BOARD OF SUPERVISORS COUNTY OF INYO

RE: U.S. Nuclear Regulatory Commission's Supplement to the U.S. Department of Energy's Environmental Impact Statement for a Geologic Repository for the Disposal of Spent Nuclear Fuel and High-Level Radioactive Waste at Yucca Mountain, Nye County, Nevada Final Report (Docket ID NRC-2015-0051)

Subject: Summary of Review – Supplement to the U.S. Department of Energy's Environmental Impact Statement for a Geologic Repository at Yucca Mountain, Nevada

Figure 3-10. Pumping vs. Time, Pahrump Valley, Nevada

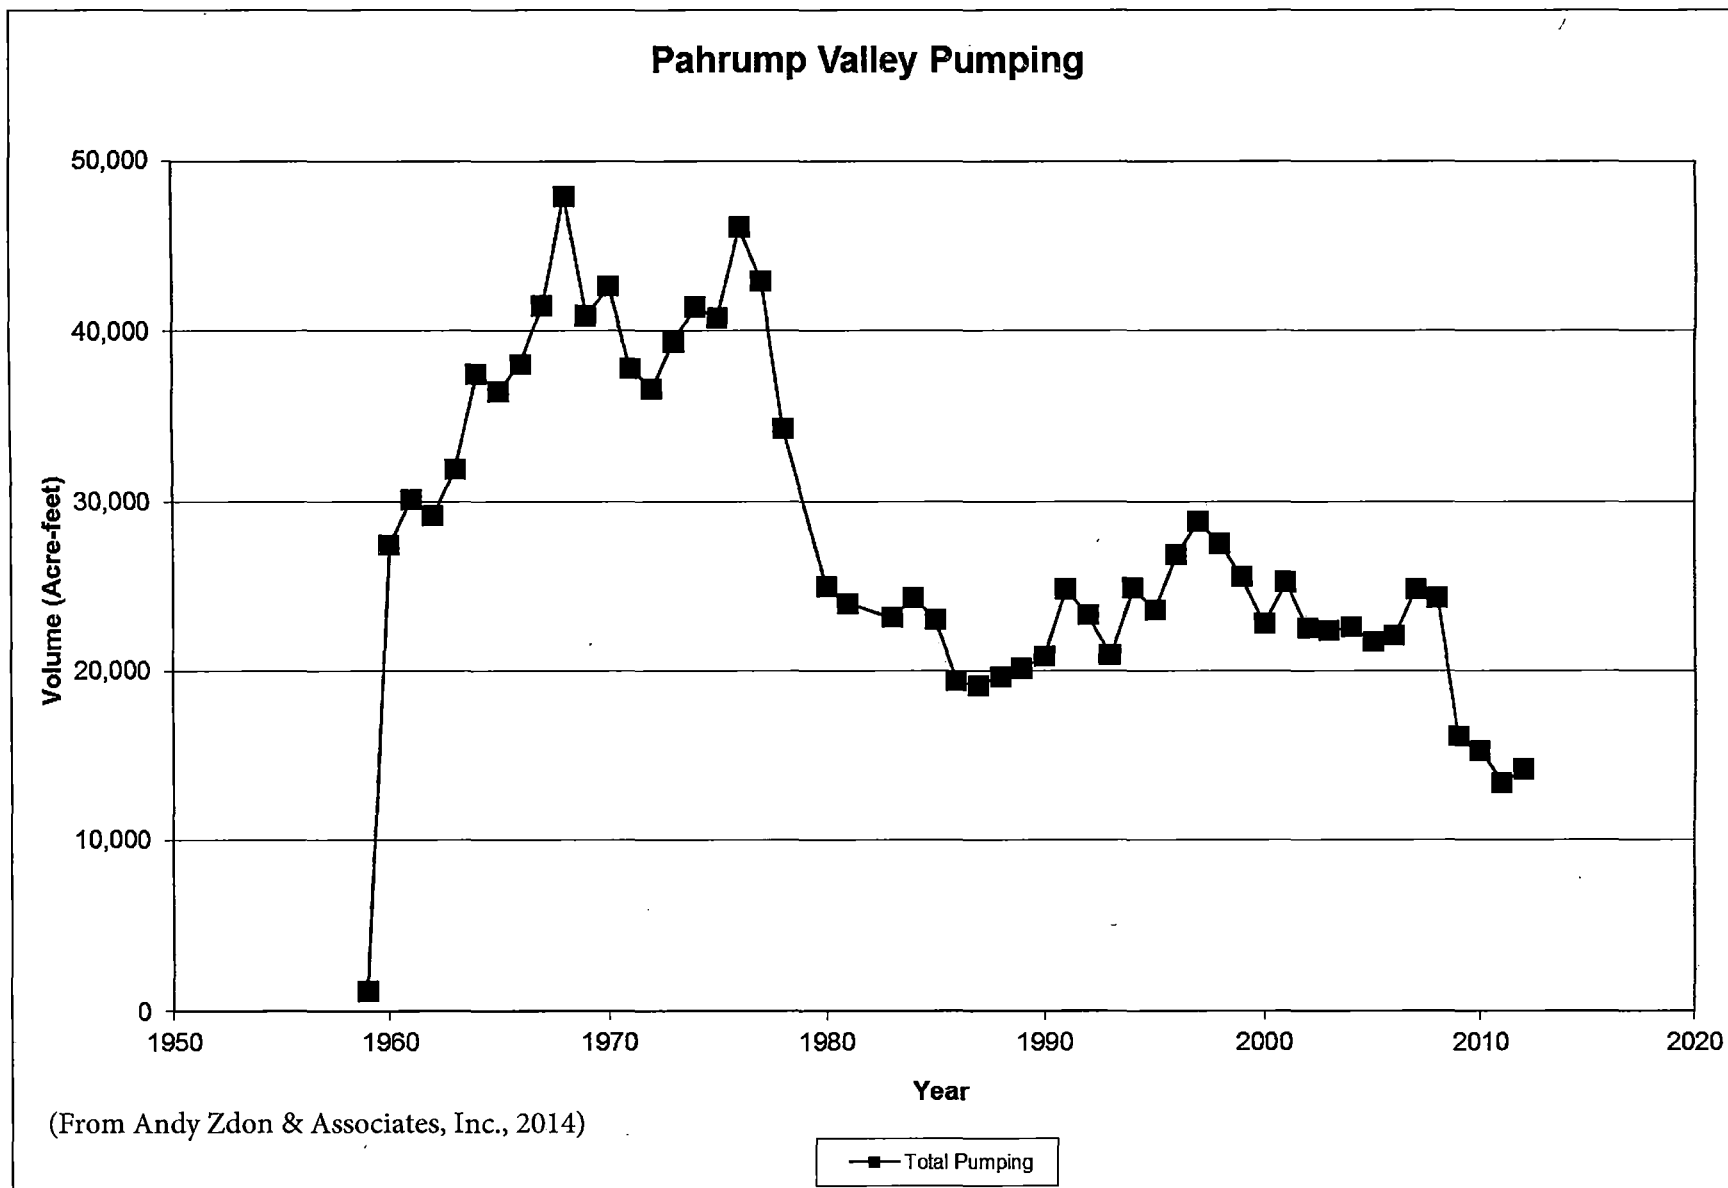
1. The Final Report continues with the flawed assumption (e.g., Section 2.1.1) that population and associated groundwater usage will continue as currently being used despite upward trends in groundwater usage in Amargosa Desert and past history showing that substantial changes to groundwater usage can occur in this region under very short time frames, as illustrated by the history of groundwater pumping in Pahrump Valley (see attached).
